Re: Response to Opinion on Site Characterization Report for K2  
Facility (VCP #NW2894)  
Vashon, Washington

Environmental Resources Management (ERM) prepared this letter on behalf of K2 in response to the Washington State Department of Ecology (Ecology) opinion letter dated 23 November 2015 for the Site Characterization Report for the K2 facility at 19215 Vashon Highway Southwest, Vashon, Washington (the "Site"). A Site Location Map is provided as Figure 1.

**Figure 2**  
*Proposed Well Location*  
*K2 Facility*  
*Vashon, Washington*

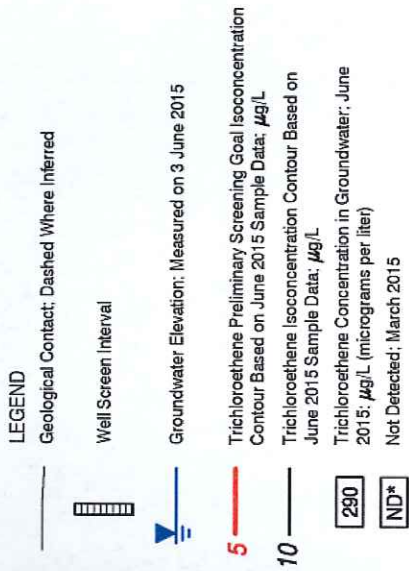
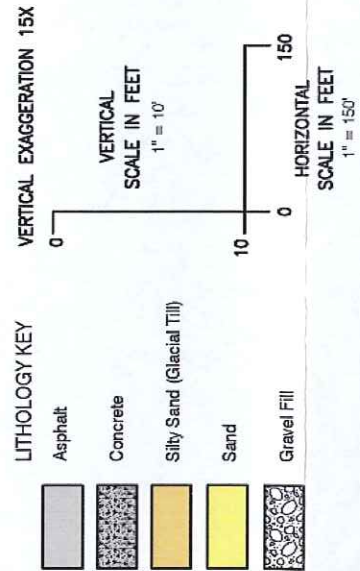
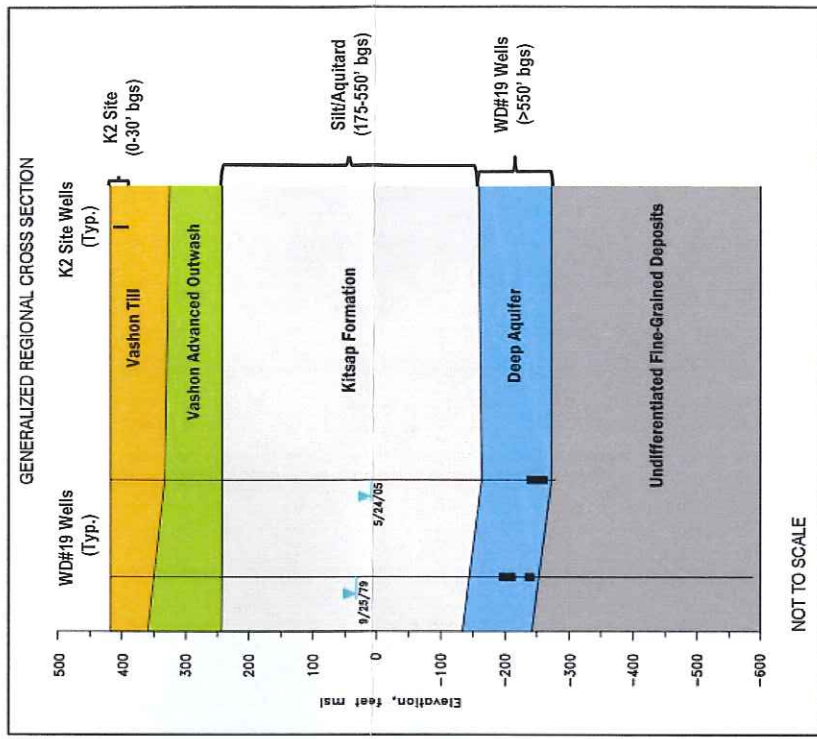
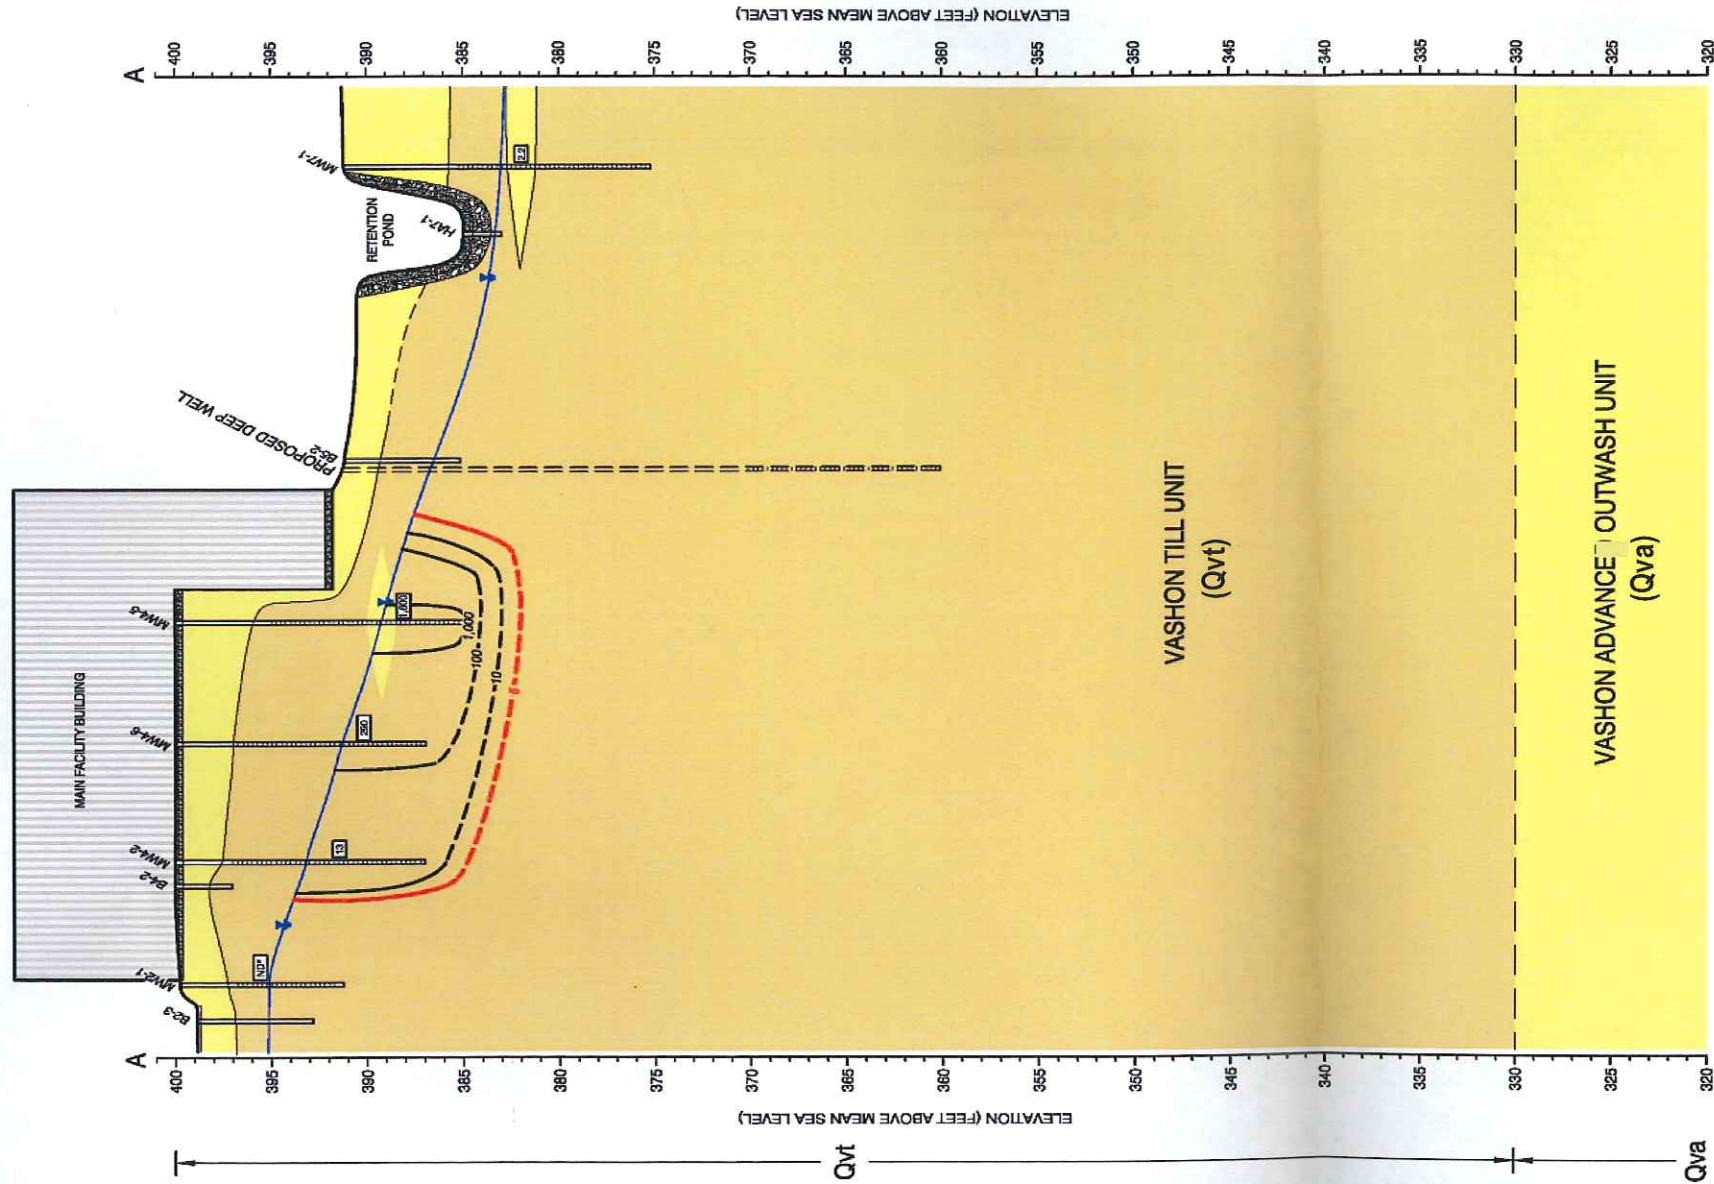
K2 and ERM appreciate your review, comments, and opinion on the Site Characterization Report. We understand that the only material data gap in the Site Characterization Report identified by Ecology in its opinion letter is the vertical extent of trichloroethene (TCE) in groundwater at the Site. The specific comment in the opinion letter is presented below:

*From analysis of Site ground water for TCE and Cross Section A-A' (Figure 9), it is apparent that the vertical extent of TCE in ground water has not been defined. The Site is within the 5-year travel time of Vashon Island Wellhead Protection Zones for Water District 19 (WD19). Ground water intakes for WD19's wells 1, 2, and 4 are at roughly 567, 640, and 598 feet below ground surface, respectively. Therefore Ecology is requiring that the vertical extent of the TCE plume be fully characterized. Additionally, Ecology is requiring that all data from this investigation be forwarded to WD19.*

K2 proposes to characterize the vertical extent of the TCE plume in groundwater at the Site by installing a single deep monitoring well downgradient of the maximum known concentrations of TCE in shallow groundwater at the Site. The well will be installed with a screen set across the next-deepest water-bearing interval beyond the depth of the current monitoring well network. The depth of the water-bearing unit and the well screen interval will be determined based on observations during drilling. An ERM geologist will provide oversight of the drilling and make adjustments in the field, as necessary. The proposed well will be installed in the Vashon glacial till unit (Qvt) and advancement during drilling will be closely monitored to avoid penetrating the Vashon Advance Outwash unit (Qva). The drilling will not proceed past 50 feet below ground surface (bgs) to ensure the Vashon advance outwash is not intersected. The proposed location of the deep monitoring well as well as a cross-section depicting Site geology are shown on the attached Figure 2 and Figure 3, respectively.

A groundwater sample will be collected from the deep well and analyzed for TCE. If the TCE concentration in groundwater is less than the Model Toxics Control Act regulation (MTCA) Method A groundwater cleanup standard of 5 micrograms per liter ( $\mu\text{g/L}$ ), no further evaluation of vertical extent of TCE would be recommended, as the vertical migration of TCE in the Vashon till in the immediate vicinity of the Site will be adequately assessed. Based on the extremely low vertical hydraulic conductivity of the Vashon till, vertical migration of TCE impacts is unlikely. Therefore, if analytical data for groundwater from the proposed well indicates that TCE concentrations at depth are less than the MTCA Method A it can be concluded that protection of the groundwater extraction aquifer for Vashon Water District #19 is appropriately evaluated. If TCE is detected in the deep well at concentrations greater than the applicable MTCA Method A groundwater cleanup standard, additional characterization will be evaluated.

the boring is advanced. In addition, the boring will be advanced no further than 50 feet bgs to avoid intersecting the Vashon advance outwash (Qva).
